TECHNICAL NOTE

Job Name: Worton Grange, Reading
Job No: 32618
Note No: 32618-TN013
Date: September 2018
Prepared By: Douglas Whittaker
Subject: Discharge of Condition 53

This Technical Note (TN) has been prepared in response to Reading Borough Council's (RBC) Highway Officer's comments dated 22nd August 2018 relating to discharging condition 53 of the consented Worton Grange (ref: 151944) development.

Figure 1: Temporary pedestrian route between Units A & B and Phase 1 & Phase 1B.

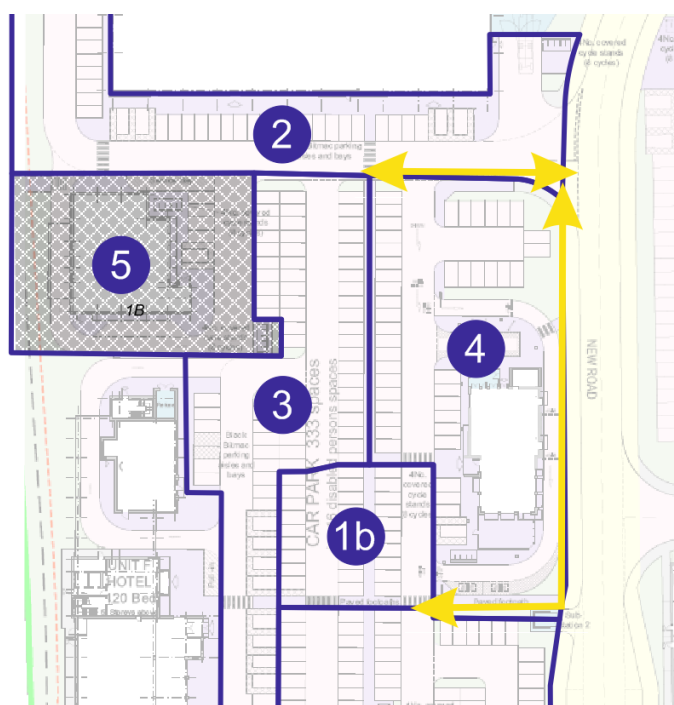
"In terms of Unit A the submitted plan identifies the area previously allocated as parking for the previous Toys R Us store as well as a provision around the edge of the store (36 spaces). Based on the floor area this is below the Council's standards and no information is provided as to how direct access to the adjacent car parking (provided for Unit C/ Toys R Us) will be provided. A footway is provided around the car park but knee rail barriers would restrict access, this should therefore be clarified with additional information.

A temporary dedicated pedestrian route from Units A and B (phase 2) to the overflow area (phase 1B) and the main area (phase 1) will be provided to facilitate pedestrian movement, as seen in **Figure 1**. The proposed option is to shorten the walking distance from Units A & B to the larger car park located adjacent to Unit C.

This route will provide safe access for pedestrian movement to Units A and B if they are unable to utilise the 36 spaces outside Units A and B. As outlined in Figure 1, the pedestrian route will utilise the built spine road footway and access the larger southern car park via the proposed paved footway located between Unit E and sub-station 2. This route will mean that pedestrians will avoid the knee-high barriers located within the landscaped area alongside the larger southern car park.
